## Comments on applications for referral under the COVID-19 Recovery (Fast-track Consenting) Act 2020

**COVID-19 Recovery (Fast-Track Consenting) Act 2020 – Park Terrace, Christchurch  
Comprehensive Care Retirement Village – Comments sought**

<b>Project name</b>	Park Terrace Comprehensive Care Retirement Village
<b>General comment – potential benefits</b>	Construction jobs; redevelopment of ageing and vacant sites.
<b>General comment – significant issues</b>	Bulk, scale and height of buildings across the two sites. Strong public interest, mainly opposing the scale and height of the buildings.
<b>Is Fast-track appropriate?</b>	The Council has recommended limited notification which is a 2-3 month process. The decision is still pending. If notified, there is a possibility of appeals once the substantive decision is made.
<b>Environmental compliance history</b>	We have no awareness of any compliance issues within the Christchurch City area.
<b>Iwi and iwi authorities</b>	Generally we would not engage with Iwi for an application of this nature. If we did we consult, we would with Mahaanui Kurataiao Limited who are the resource management consultation body for Te Rūnanga o Ngāi Tūāhur

Figure 4: South façade B02 (Bishopspark)  
Source: Application documents

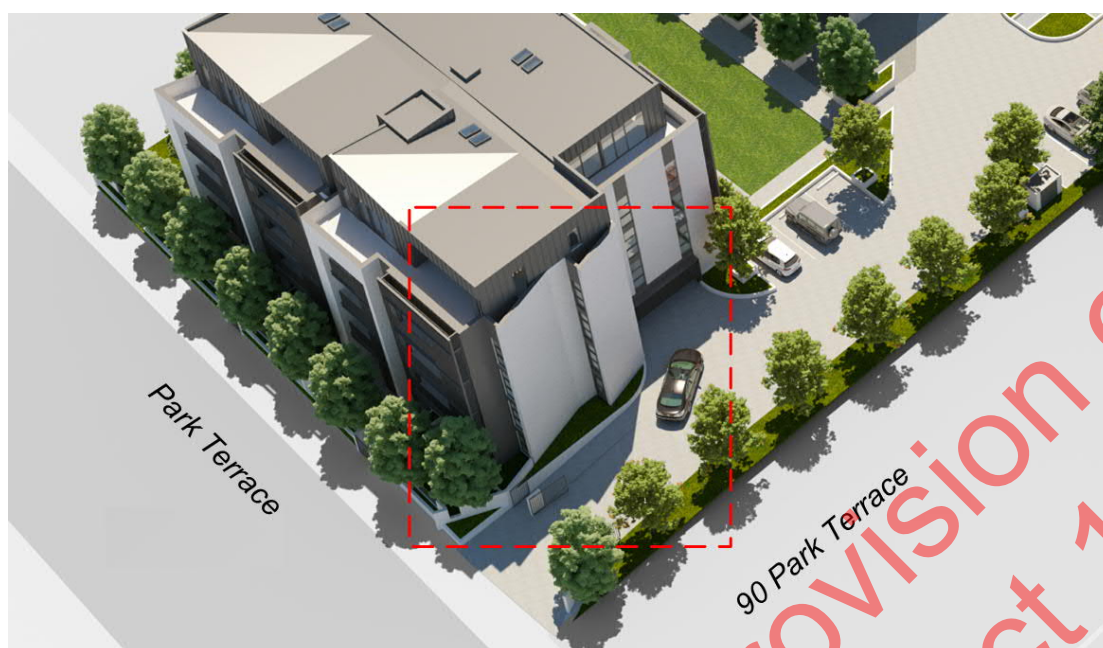
- *South façade B02 (illustrated below).* Similarly to the north facade this elevation while angled, is tall and relatively blank, with additional roof height increasing the visual bulk, with potential for a high level of reflectance. Ms Schroder considers that will result in a moderate to significant visual impact, resulting in visual dominance, in respect to 90 Park Terrace and to a degree, albeit at greater distance on 84 Park Terrace.

Figure 5: Areas where height plane breached (Bishopspark)

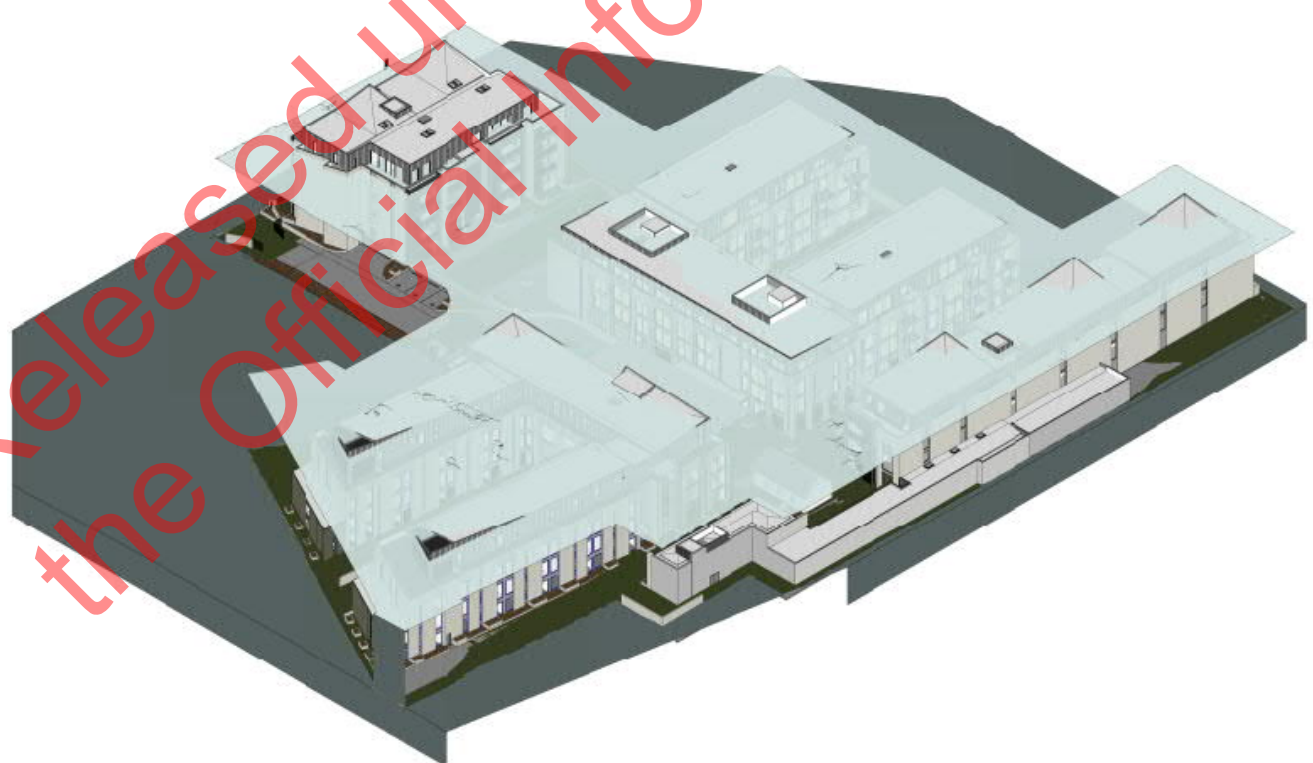
In terms of height, part of each of the buildings on the Bishopspark site proposed exceeds the permitted height, with the most significant height intrusion being on Building B02 by 4.5m for the extent of the top storey. The remainder of the buildings have partial roof intrusions, up to 2m in height. The applicant has provided a useful diagram which clearly shows the areas of buildings which intrude the height plan. Although not to scale the diagram clearly identifies the height intrusions across the site.

Figure 6: Recession plane breaches NW (Bishopspark)  
Source: Application – Recession Plane - North West – Drawing No. S01.A0-070

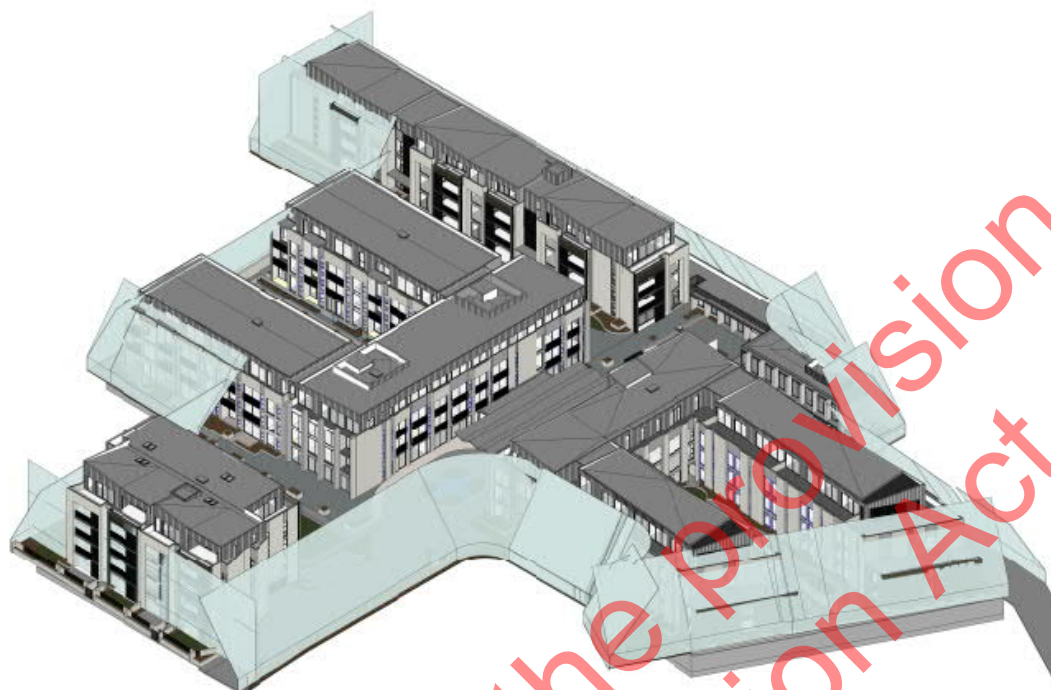
The proposal also breaches a number of recession plane rules at almost all boundaries, albeit at various heights, lengths and depths. Similar to the height intrusions, the applicant has provided a number of useful drawings which clearly shows the areas of buildings which intrude the recession planes, see below.

Figure 10 Height Plane NW (Peterborough)

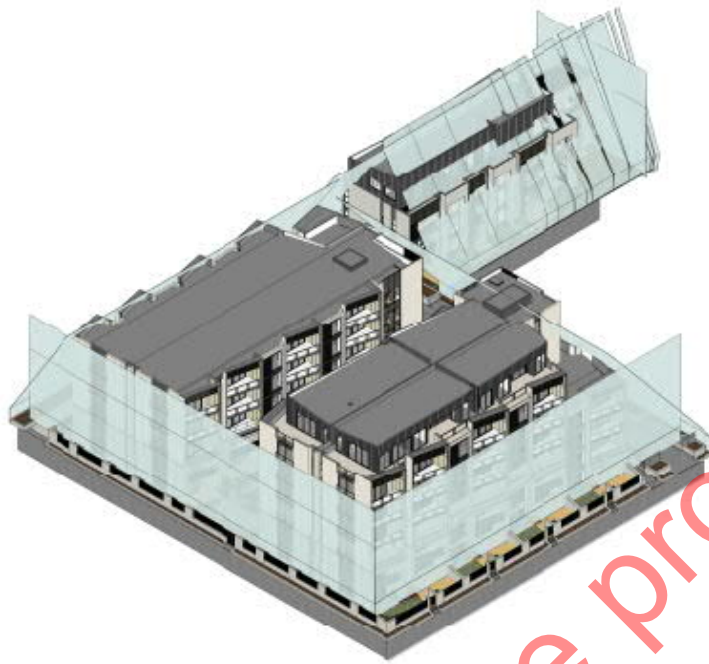
The proposal also breaches a number of recession plane rules at almost all boundaries, albeit at various heights, lengths and depths. Similar to the height intrusions, the applicant has provided a number of useful drawings which clearly show the areas of buildings which intrude the recession planes, see below.
